**Addendum #2**

**Bid Opportunity: RFT-2025-166 - Operations Centre Garage Expansion**

ADD  
#E01

ADD  
#M01

S2.1

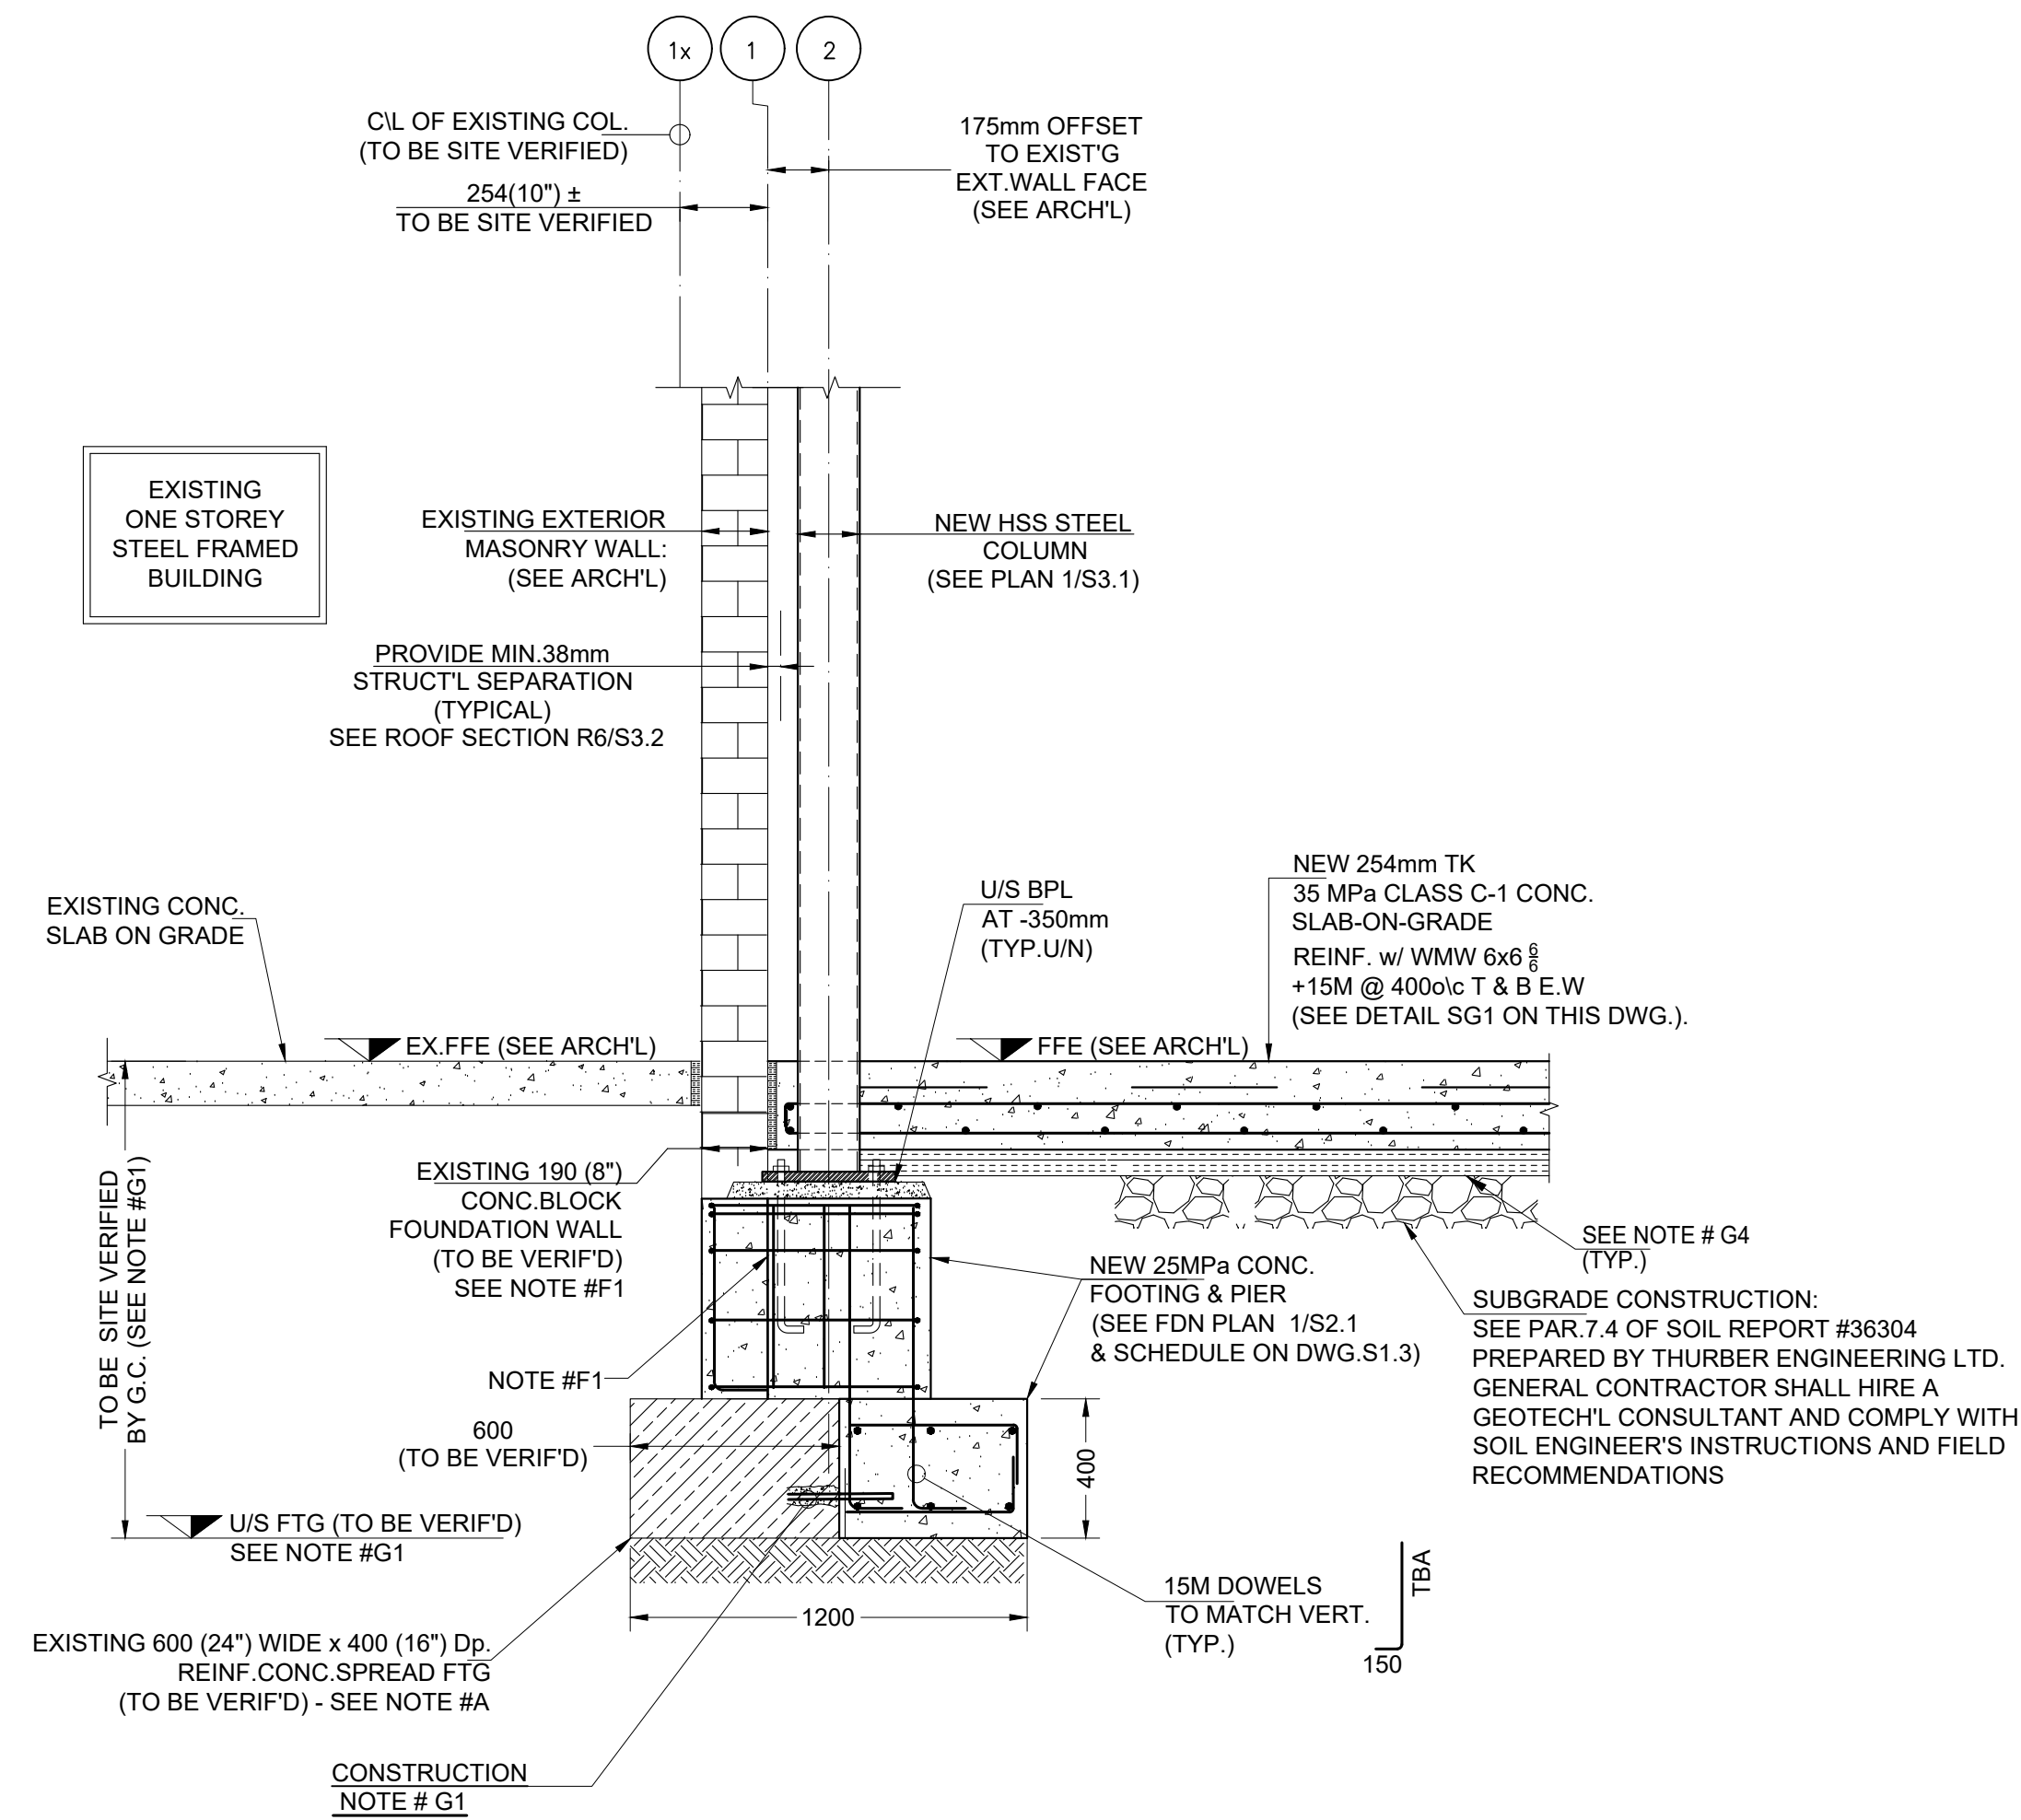
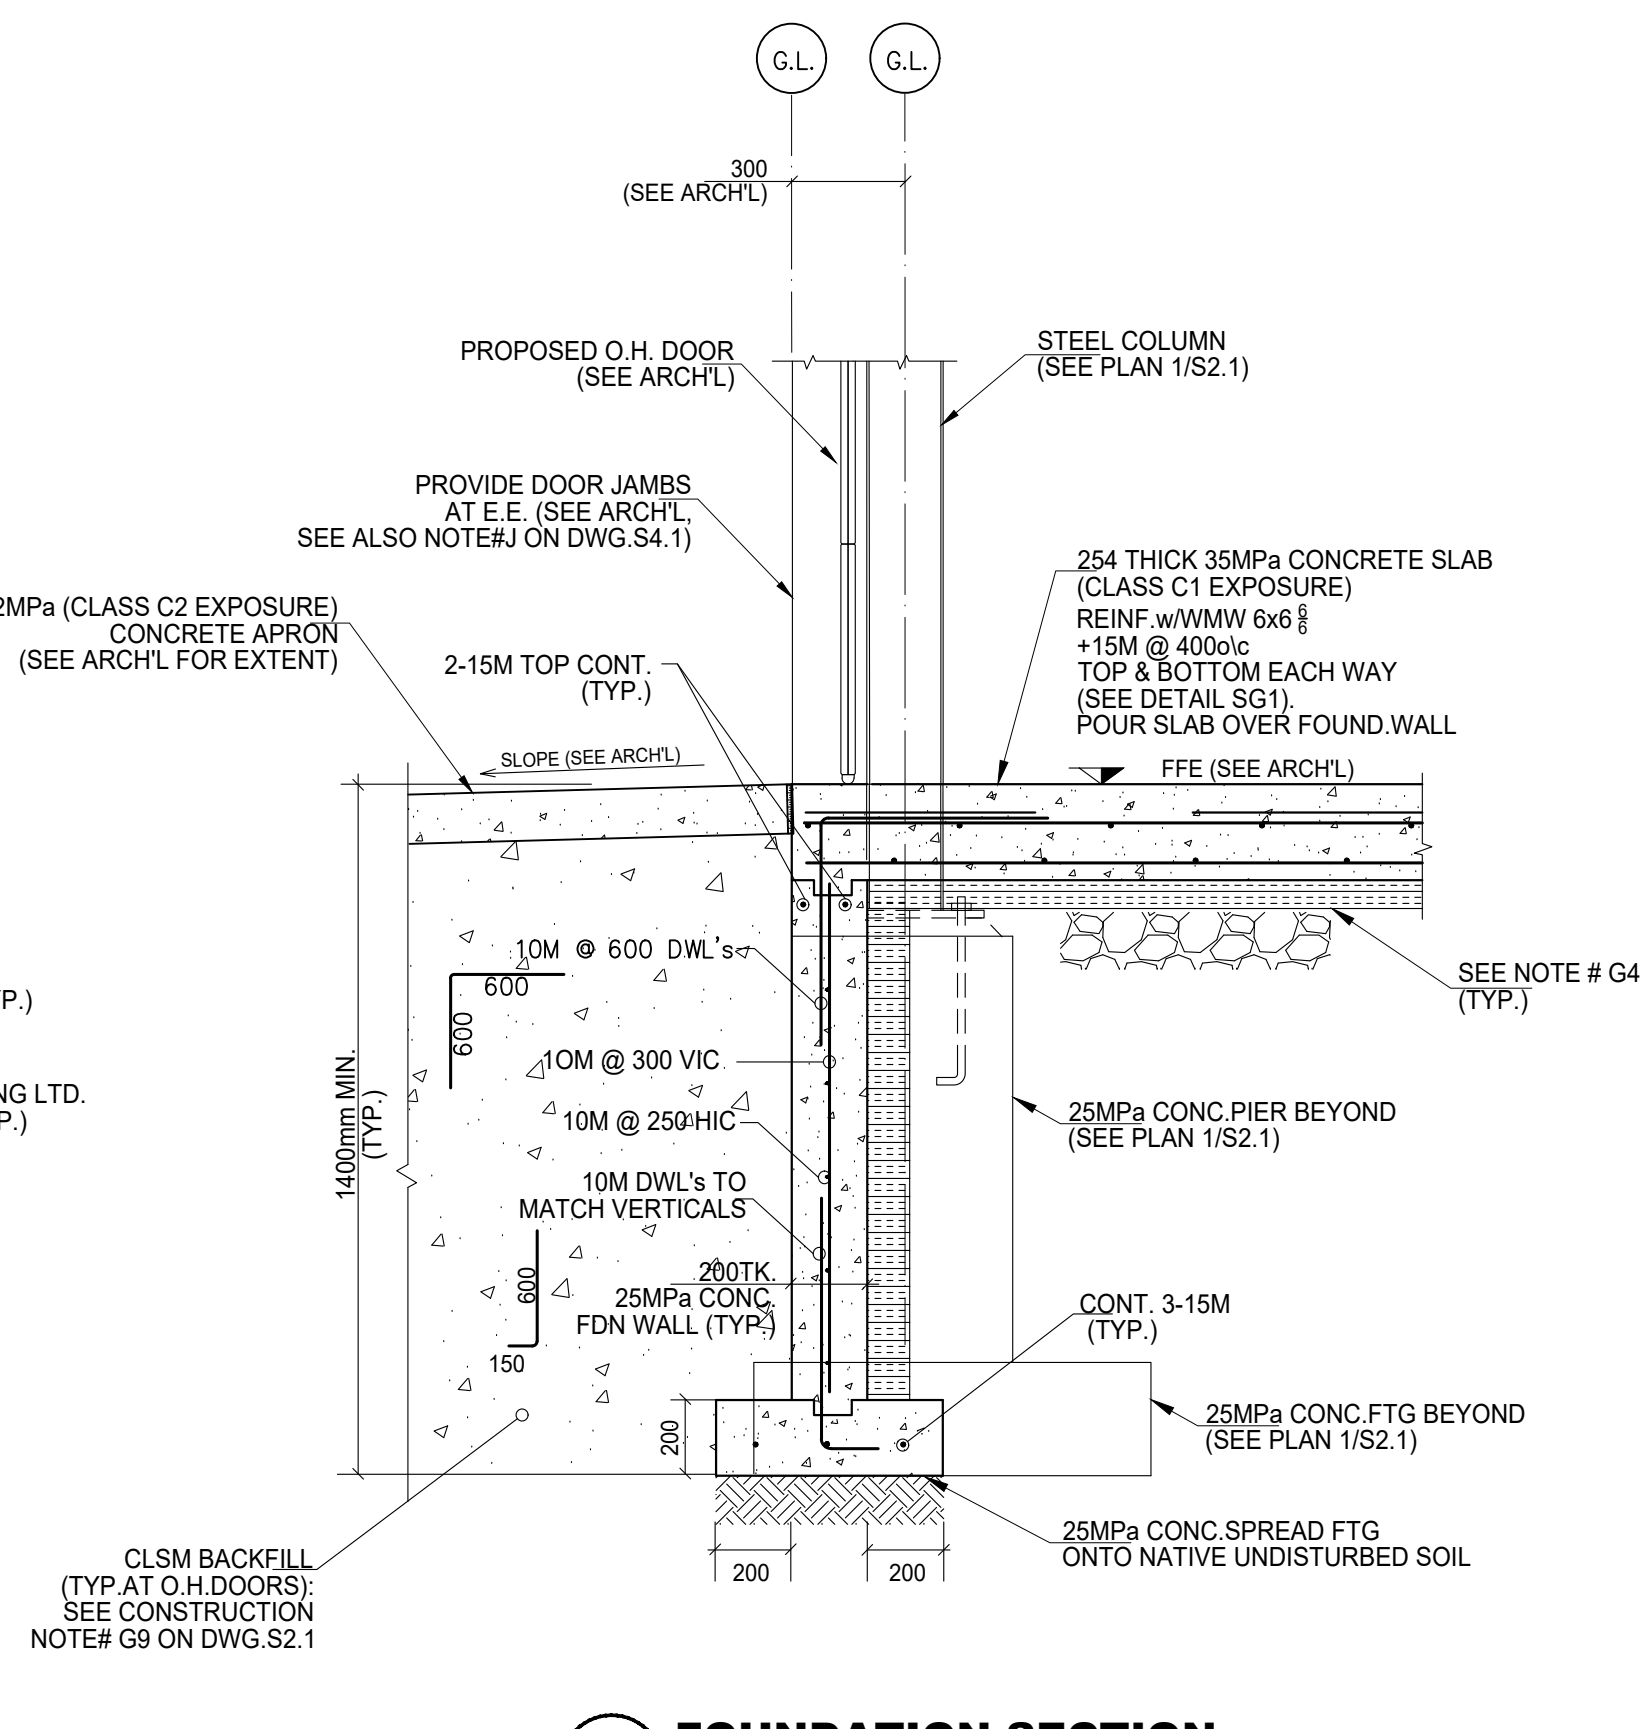
Conflicting notes between plan A-102 notes 3in. tk. insul. at perimeter and then plan S2.1 note G4 states 2in. tk?

**Answer 12:** For clarification, as per the architectural drawing A-102 the thickness of the perimeter insulation will be 3 in. See attached & updated structural drawings S2.1 & S2.2 indicating the thickness of the perimeter insulation has been revised from 2 in. to 3 in.
